# Delegated Report

## Discharge of Condition Application

| <b>Planning Application No:</b> | 20220735                                                                                                                                                                                                                                                                                  |
| <b>Location:</b>                | 6 Berkley Crescent and 48 Harmer Street, Gravesend, Kent                                                                                                                                                                                                                                  |

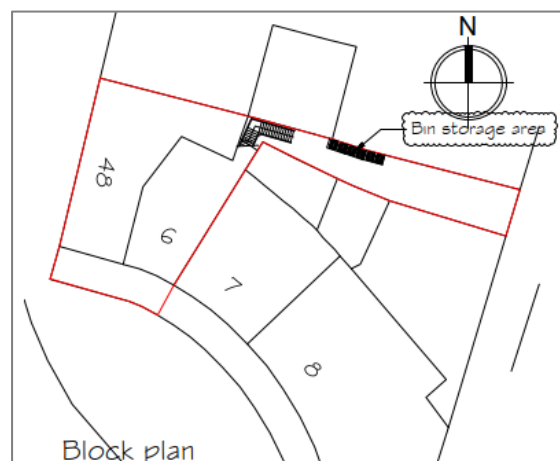
*A refuse store is shown at the rear of the building. The store will be used by the tutoring office with bagged waste being put out for collection by a private waste contractor.*

*The occupants of the flats will put out their waste by the side door to Harmer Street... with food waste being stored under the kitchen sink and put out on the weekly collection day.*

*The waste store to the rear will be...a timber store as per the photograph below. Commercial waste will be put out by the Harmer Street entrance for collection on the day of the private collection service.*

Further to comments from GBC Waste about the lack of appropriate refuse storage, the agent submitted drawing no. 20/297/04 Rev. L (Proposed first and second floor plans), which shows a bin store area in the rear yard.

The submitted details are considered to be in line with the reason for condition 8. The details are therefore considered to be acceptable and condition 8 can be discharged.
